REQUEST FOR INFORMATION DATE: May 27, 2016 NO.: RFI-121

Project Name: 15051-Webster University Interdisciplinary Science Building Project No.: 15051

Subject: Elevator Sump Pit Cover

RESPONSE TO RFI #170

P0101.A

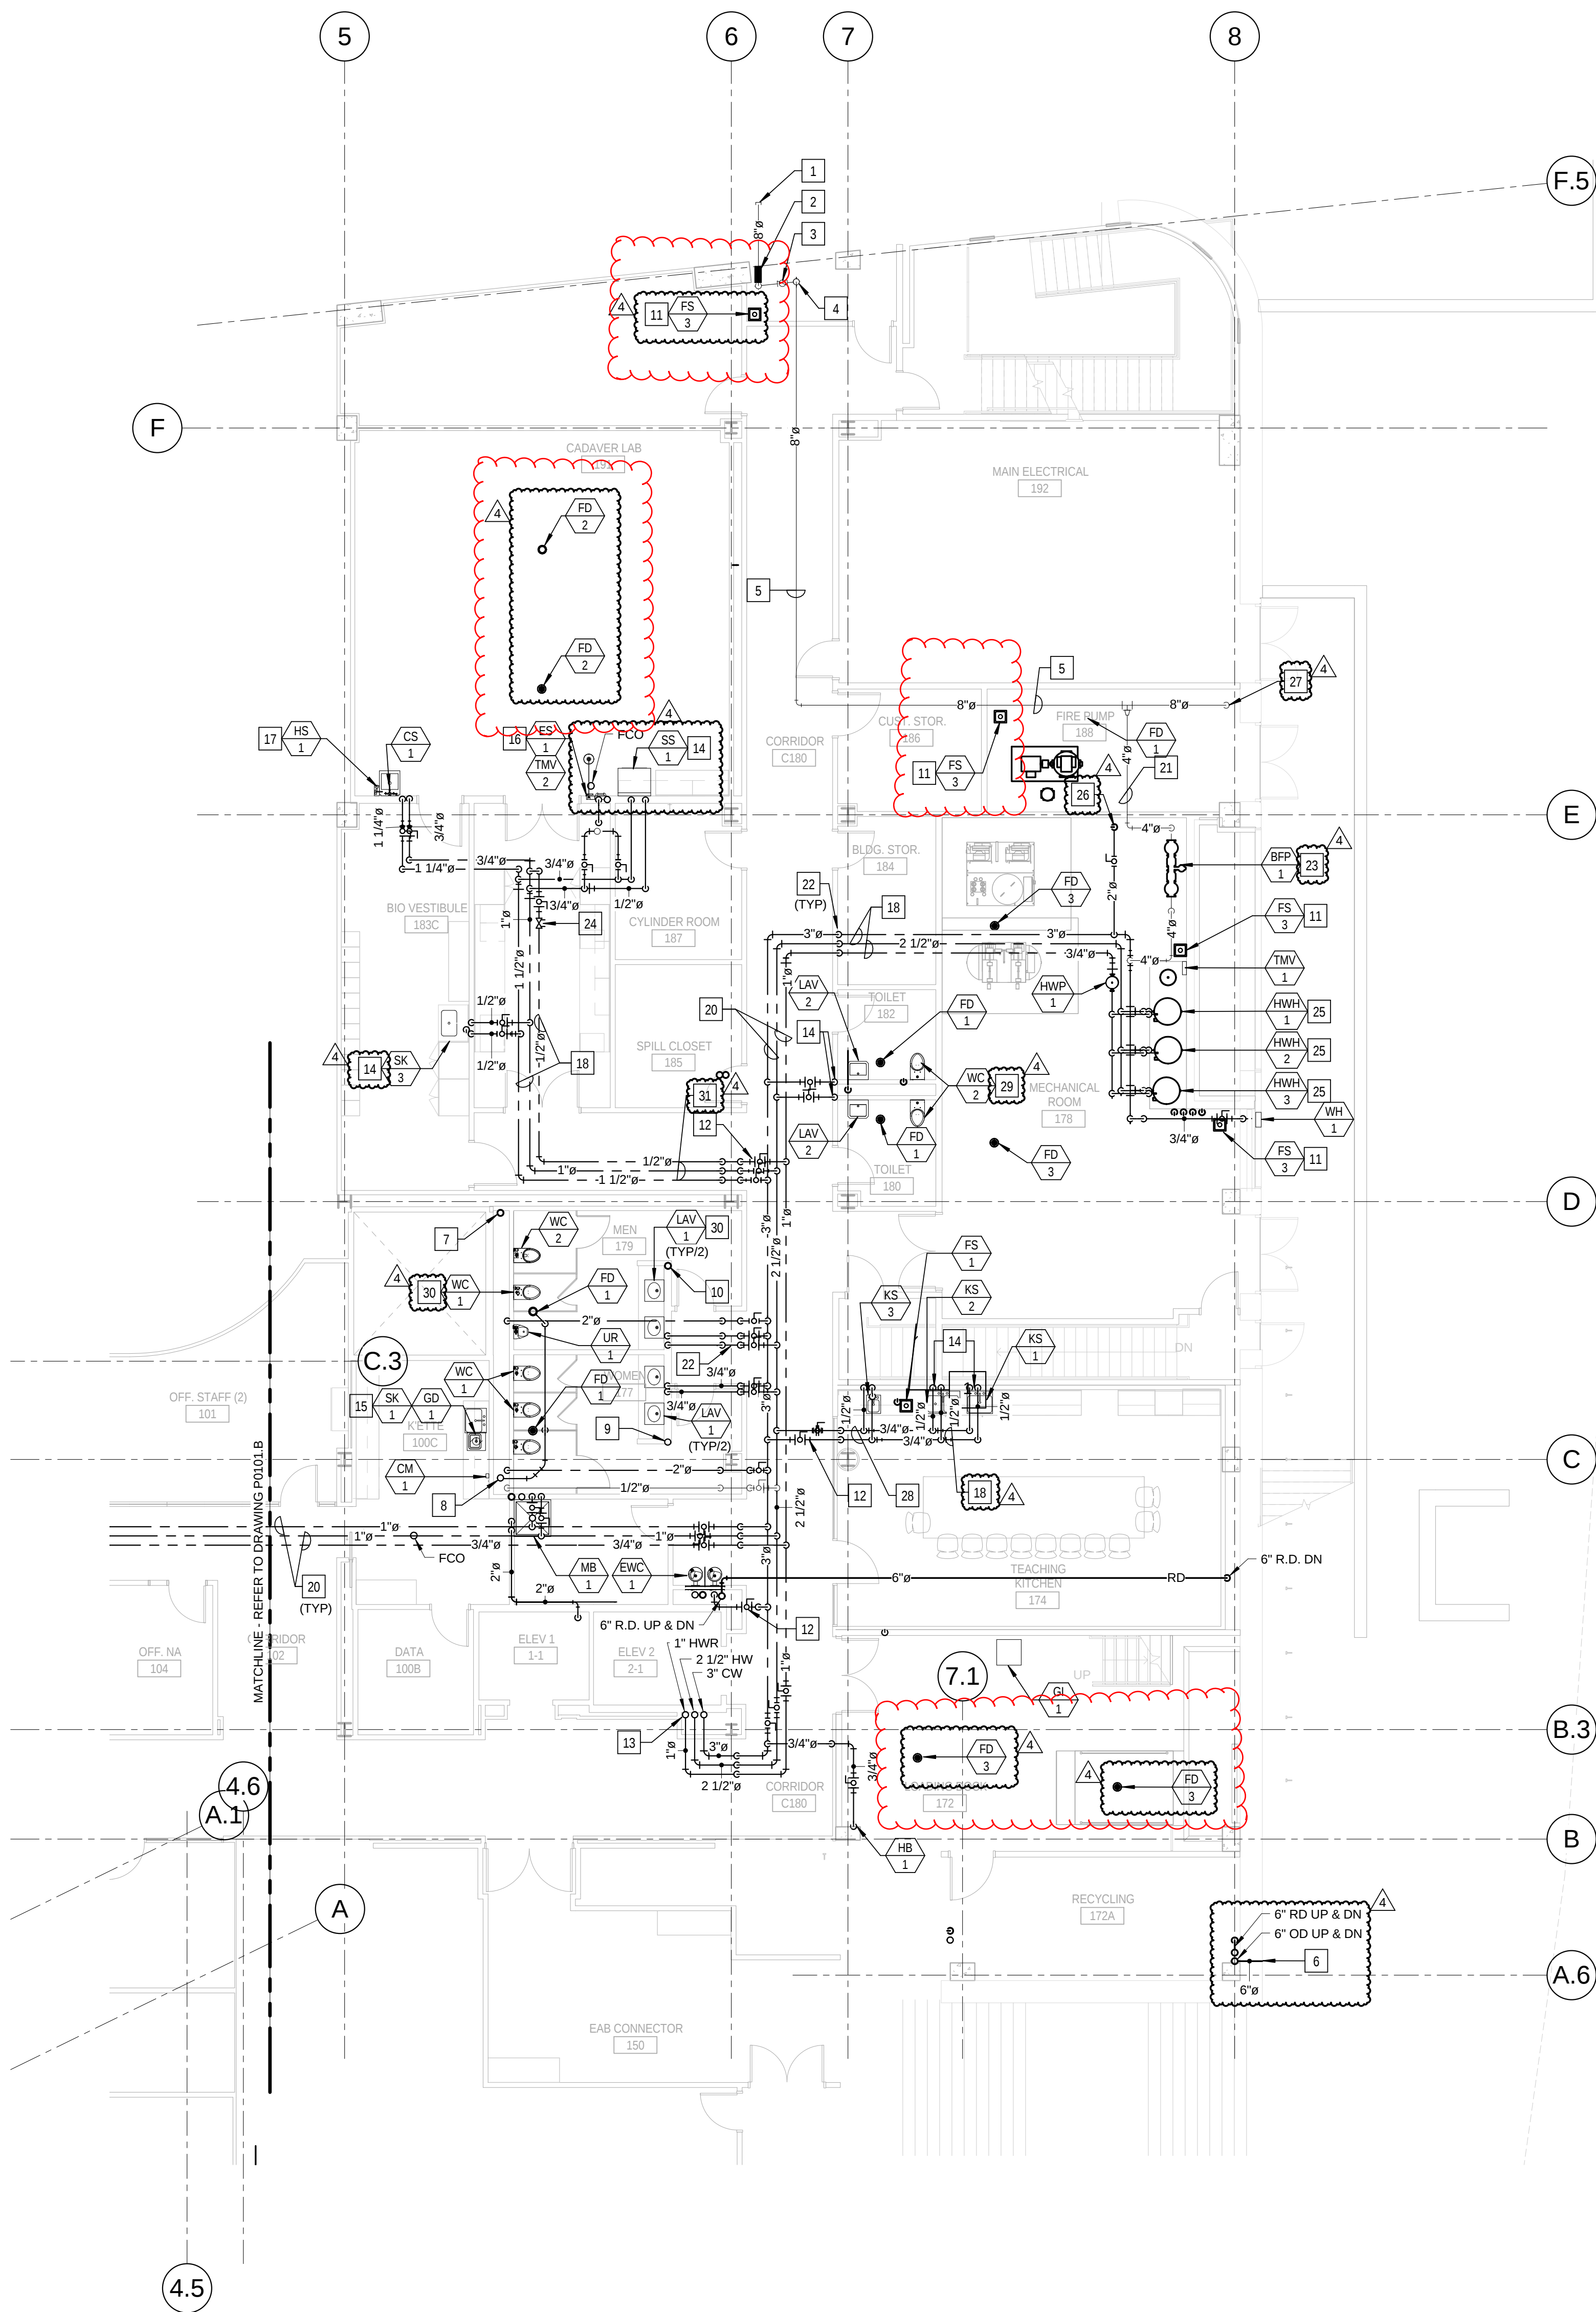
Sheet: P0101.A

Will the following drains receive regular drainage to maintain the p-trap seal, or would a trap primer supply need to be added?

196 Water Entry – FS-3
191 Cadaver Lab – FD-2 (2)
178 Mechanical Room – FD-3 (2)
172 Loading Dock – FD-3 (2)

It is the recommendation of R&B that the contractor requested trap primers be installed in the called out locations. Without the primers these areas can dry out more rapidly than in normal use areas.

If **St. Louis County allows** the use of trap seals, this can be an alternative to the trap primers. Have the contractor confirm that the county will or will not allow the use of trap seals.
